### FAIRLIGHT BOARDING HOUSE

195-197 SYDNEY ROAD FAIRLIGHT NSW 2094

**S4.55 SUBMISSION**

DRAWING TITLE: ELEVATION NORTH + SOUTH

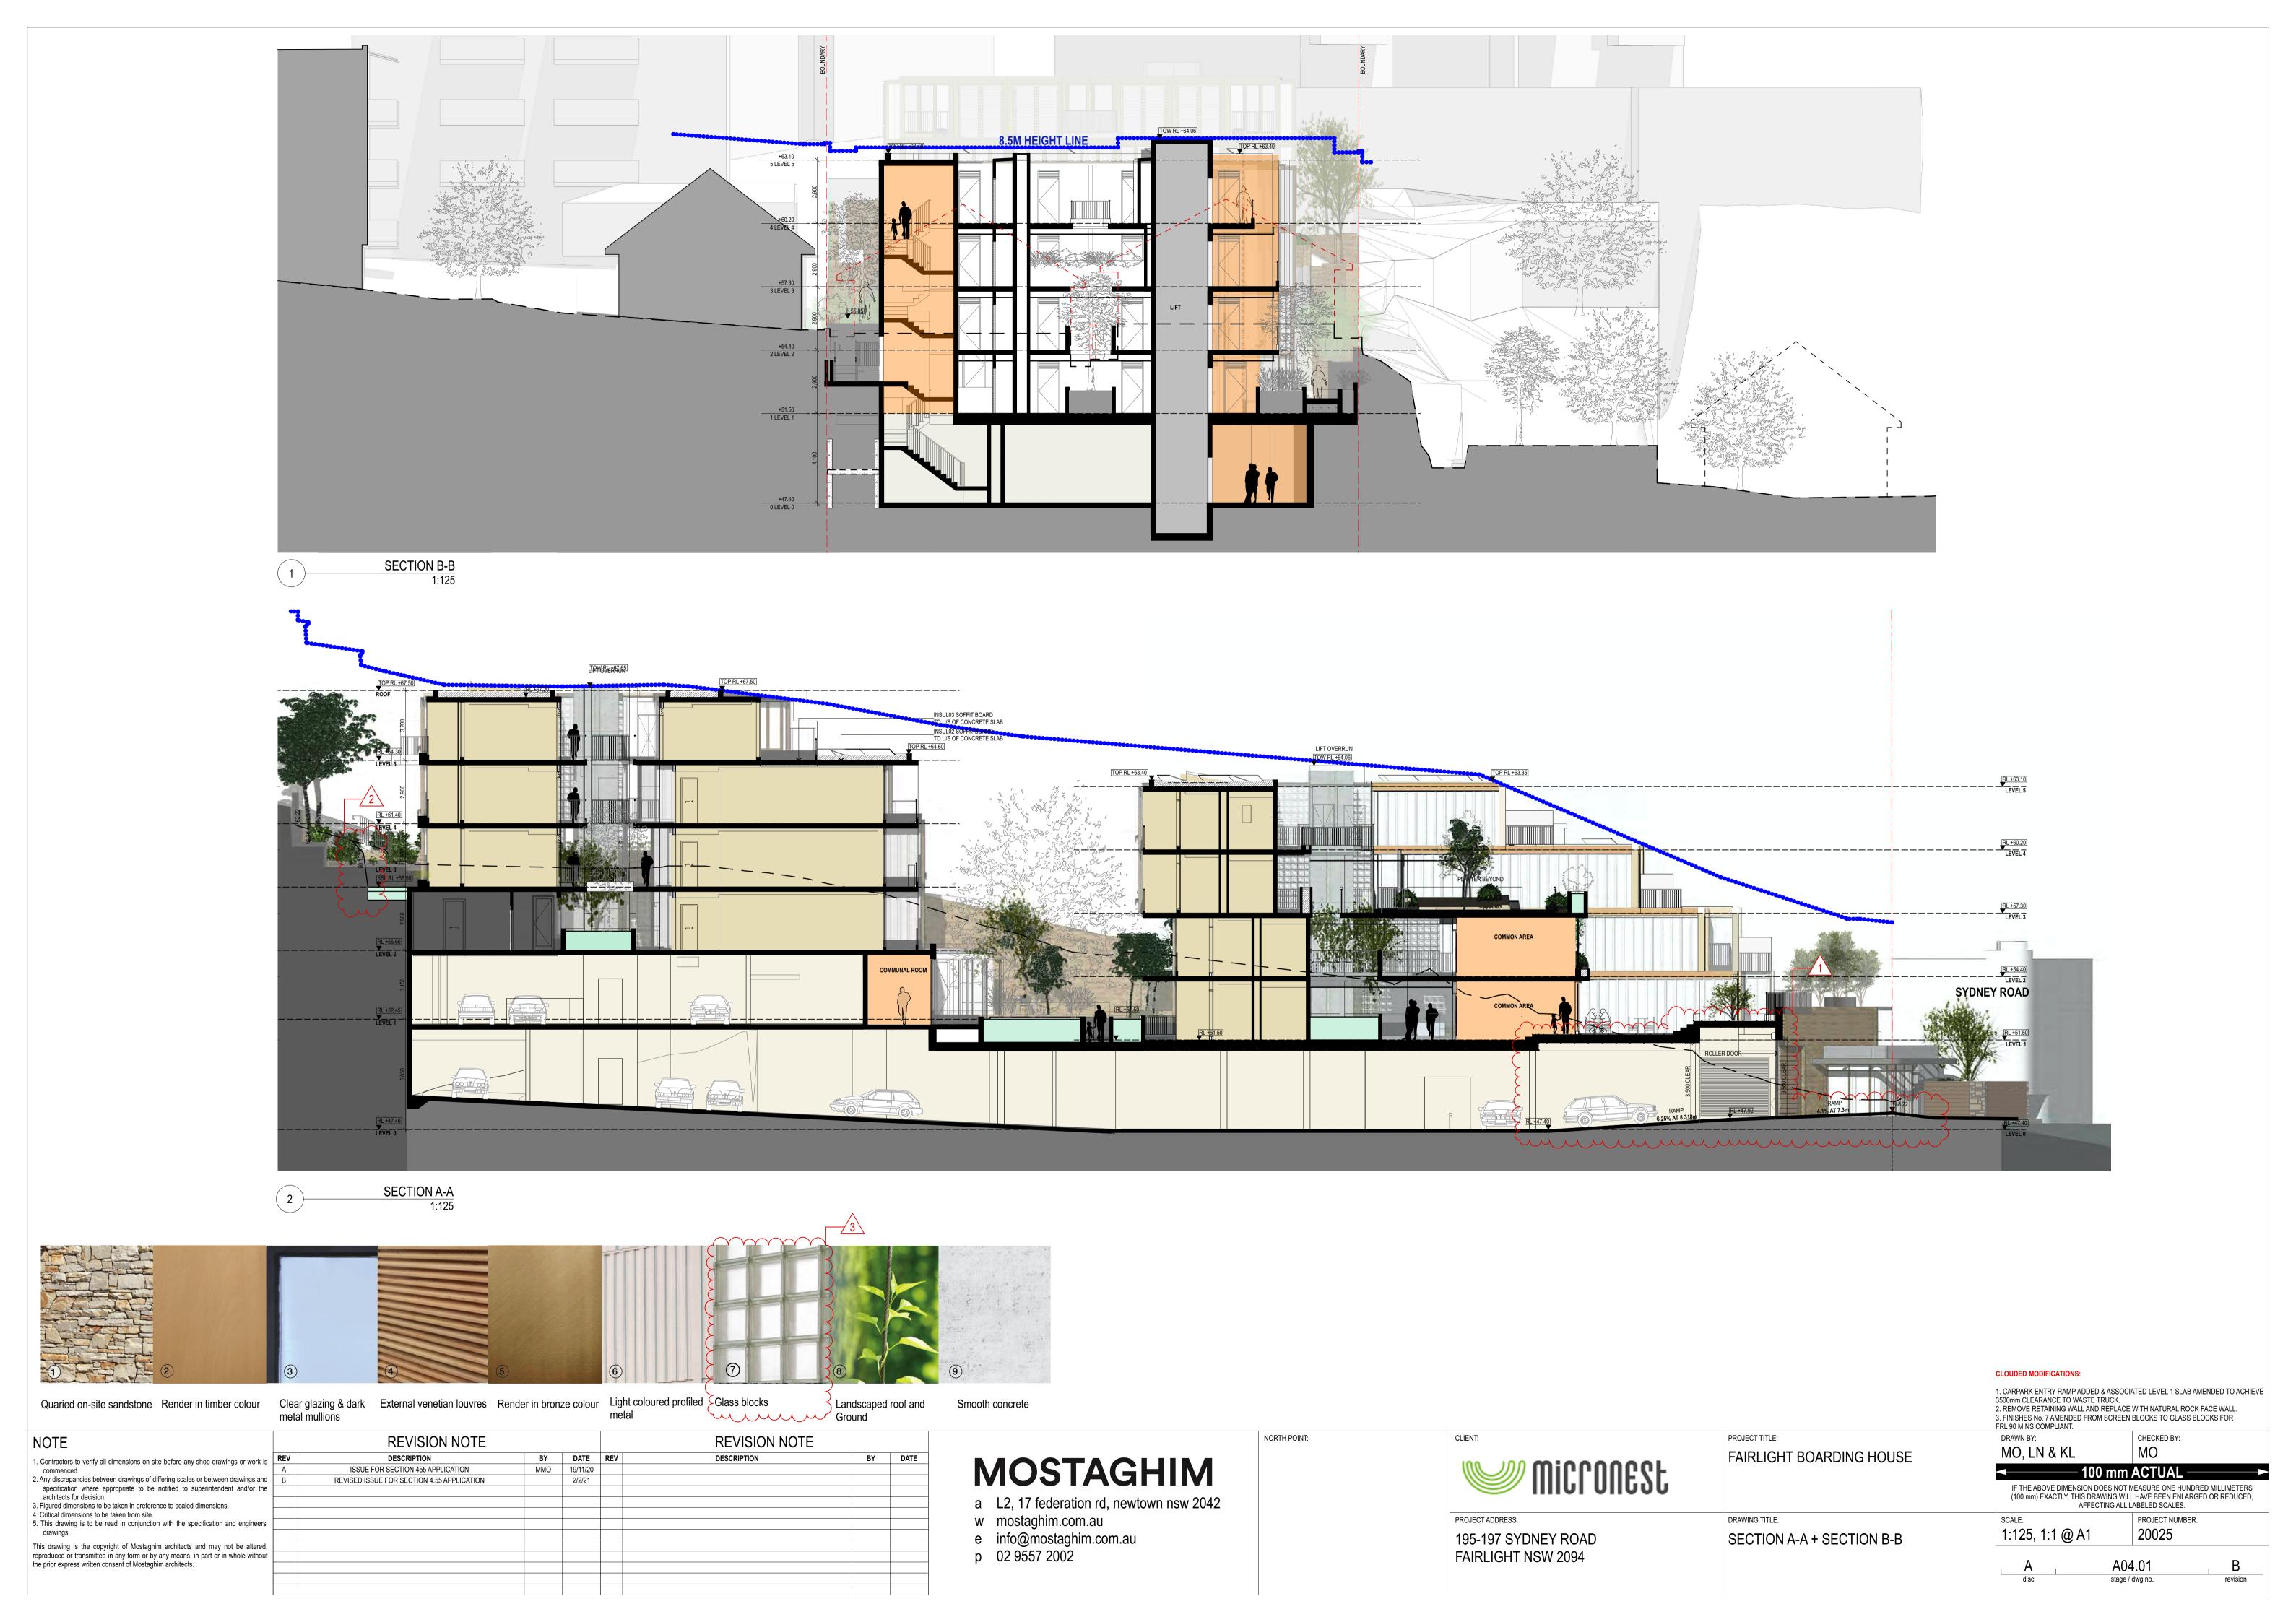
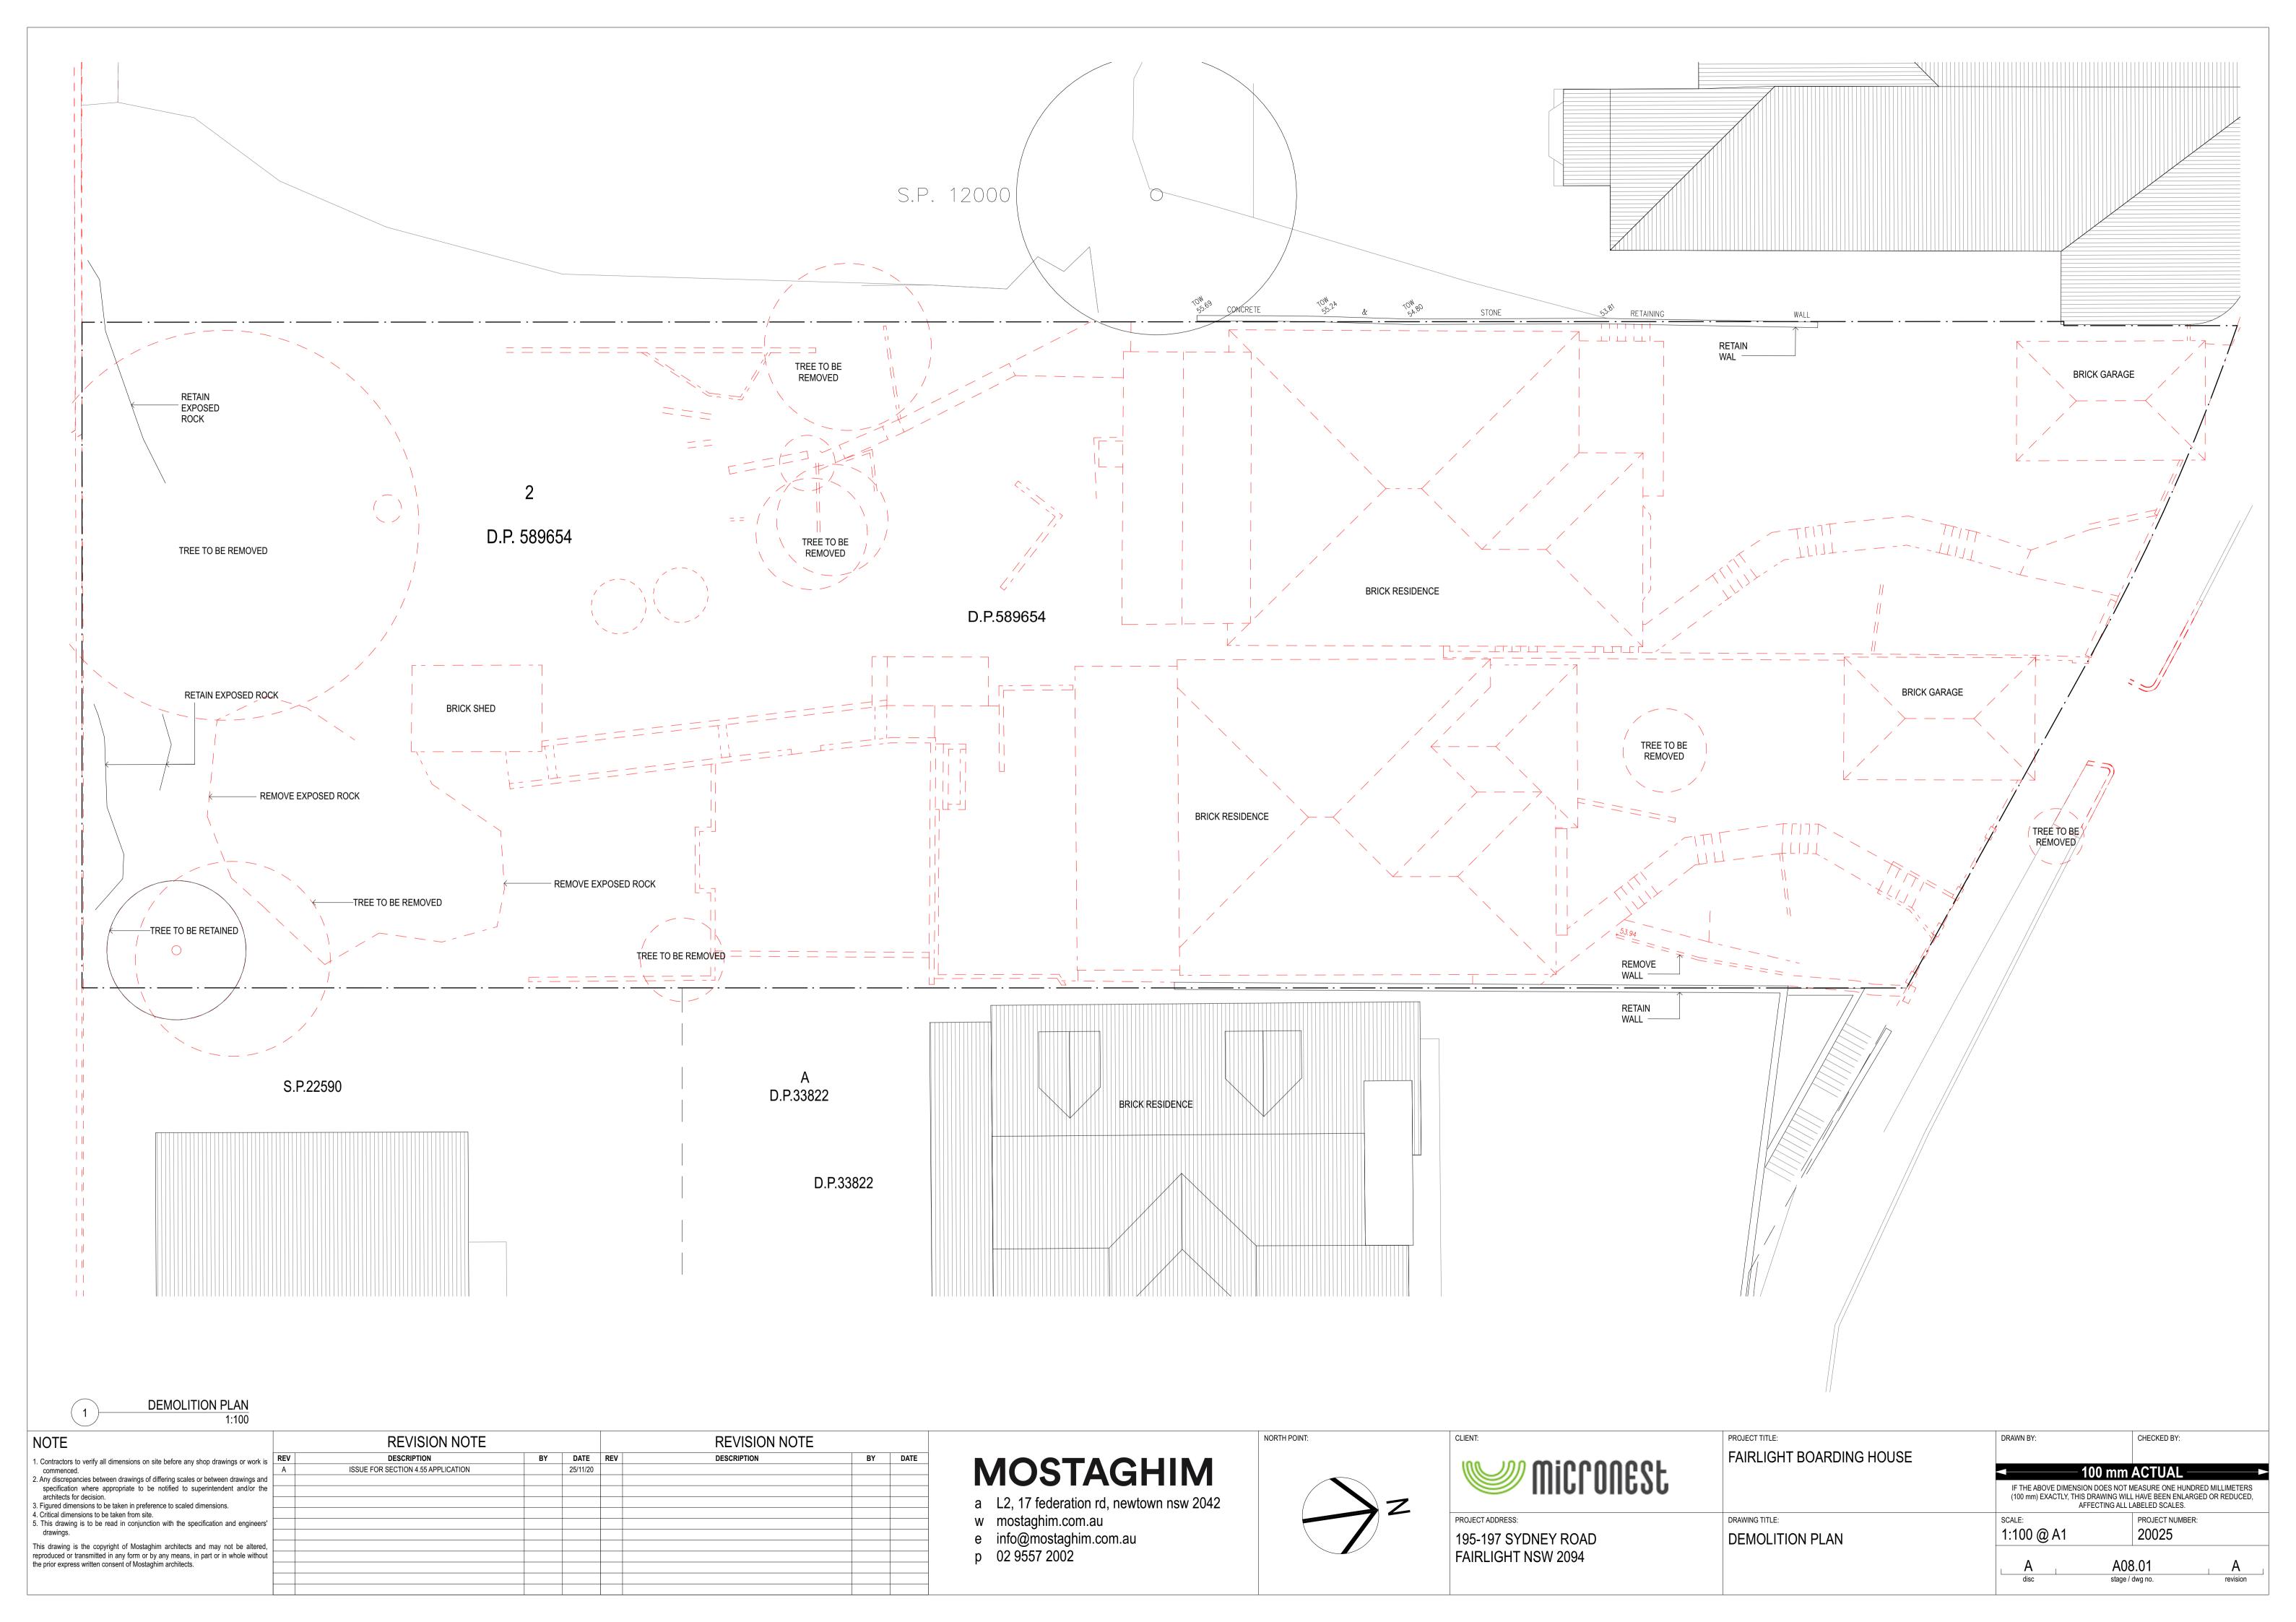
FIRE BOOSTER/HYDRANT, GAS METER & WATER METER CUPBOARD HEIGHT AMENDED FOR COMPLIANT.
 FINISHES No. 7 AMENDED FROM SCREEN BLOCKS TO GLASS BLOCKS FOR FRL 90 MINS COMPLIANT.
 CHANGE DOUBLE HINGED GARAGE FULL HEIGHT DOOR TO A ROLLER DOOR.
 RAISE WALL TO ACHIEVE 3500mm CLEARANCE TO TRUCK FOR ACCESS TO LEVEL 0.
 ADD GATE.
